## Customer Information Notification

201209004I

## Change of Product Marking for SOT89

*Change of marking code SOT89  
(CIN 201209004I)*

<b>Old marking code (as announced in PCN 201108004F)</b>		
<b>New marking code</b>	<b>BFQ591</b> 	<b>All others</b> 
	<b>Vendorcode: "W" for APG</b>

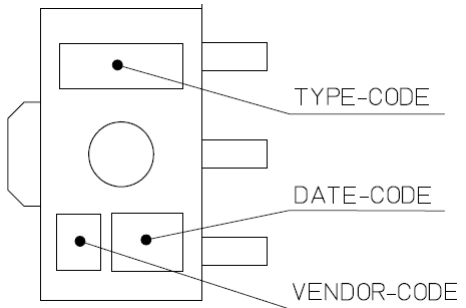
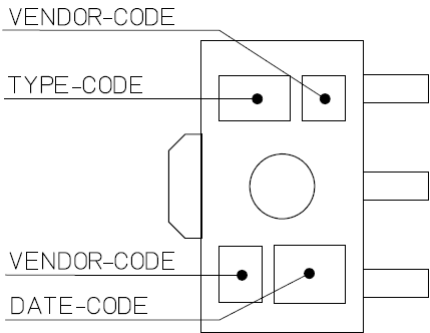
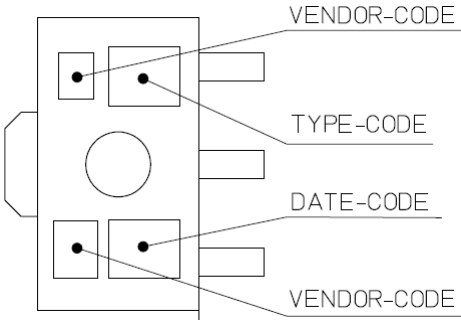
In PCN 201108004F (Transfer of Assembly line SOT89) it was announced that the marking code that was used in the assembly side NXP assembly site Hong Kong (APHK) will be changed. Due to customer demand this change will be revised, the marking code will be changed again to the appearance it had before the assembly transfer.

Only the marking code will be changed. The vendor code ("W" indicating NXP assembly site Guangdong (APG)) will be placed in the top row in addition to the bottom row.
